August 26, 1992

Mr. Paul Courtney, Project Manager
Indiana Department of Environmental Management
Office of Environmental Response
5500 West Bradbury Avenue
Indianapolis, Indiana 46241

RE: Four County Landfill Site
Site Background Summary and Detailed Statement of Work
Response to Review Comments

**GROUND WATER MONITORING WELLS AND PIEZOMETERS
PROPOSED FOR SAMPLING⁽¹⁾
FOUR COUNTY LANDFILL SITE
FULTON COUNTY, INDIANA**

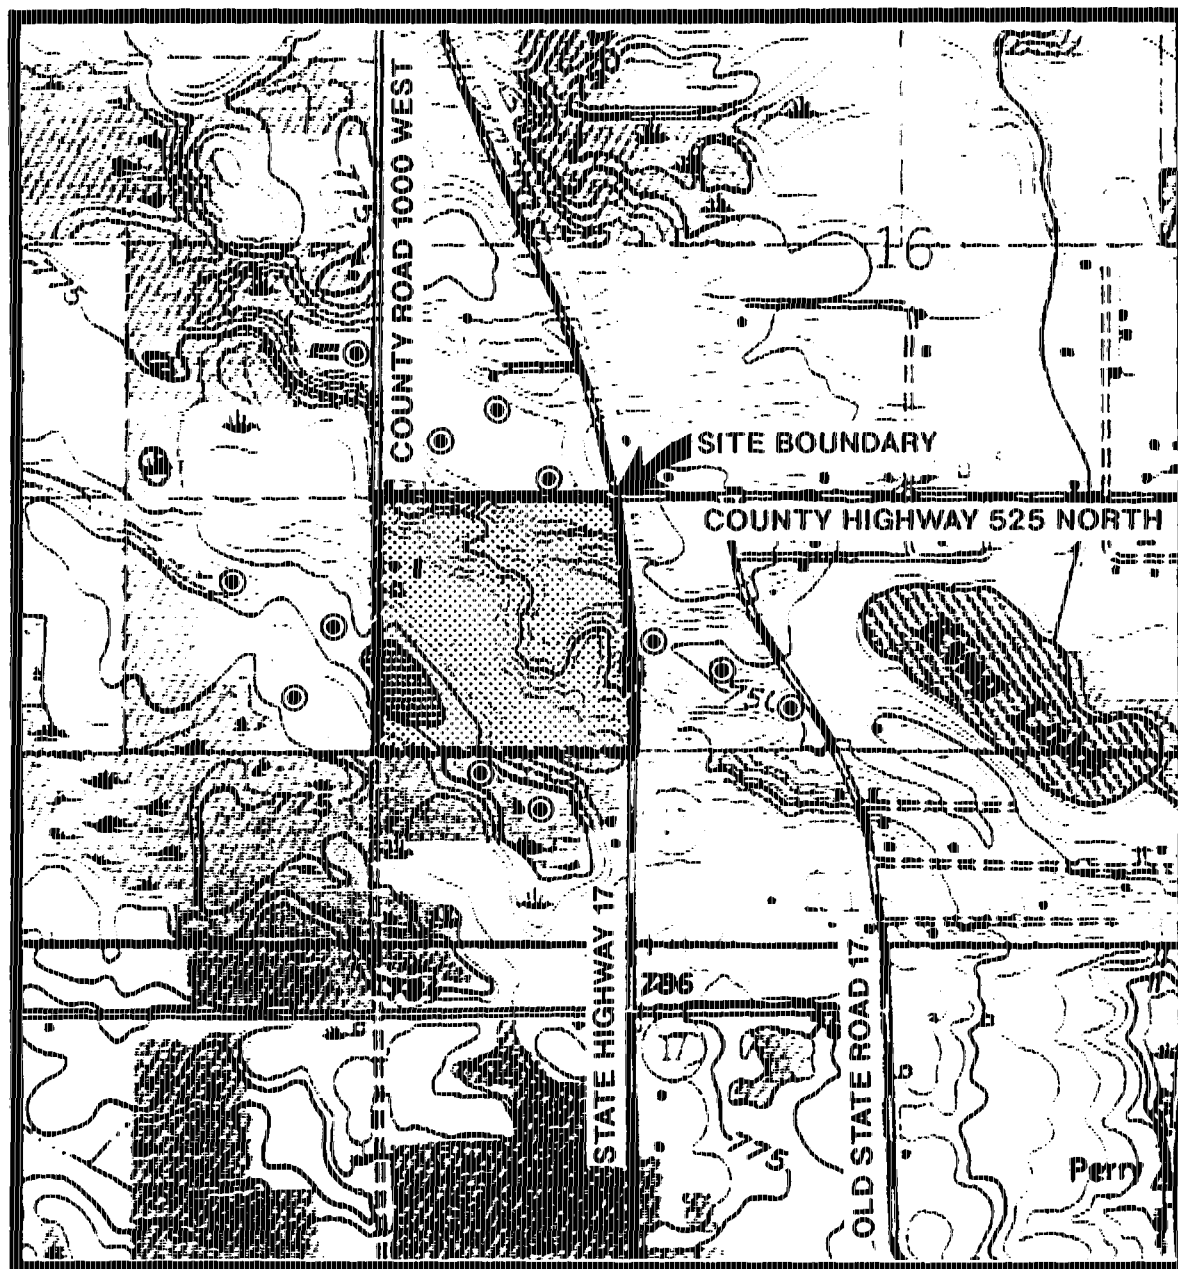
Comment 23. Table 6-4, Ground Water Monitoring Wells and Piezometers Proposed for Sampling.

The IDEM counts twenty piezometers shown on Figure 1-2 which were either not designated for abandonment or identified for sampling. Please indicate what the disposition is or will be of these wells.

Response: As stated in Section 6.2.1.5, monitoring wells/piezometers installed below stratigraphic subunit C2 (i.e., those with "C3" and "C4" numeric designations) will not be abandoned (with the exception of piezometer P-4C4) or used for the initial round of ground water sampling. However, the wells will be retained for potential future use, depending on the results of the initial round of ground water sampling. The number of sampling points with the C3 or C4 designation that are not proposed for abandonment or sampling is 19. The 20th well counted by IDEM may have been the water supply well in the northwest quadrant, which is not anticipated to be used during the RI/FS. Sump P-34A has been removed
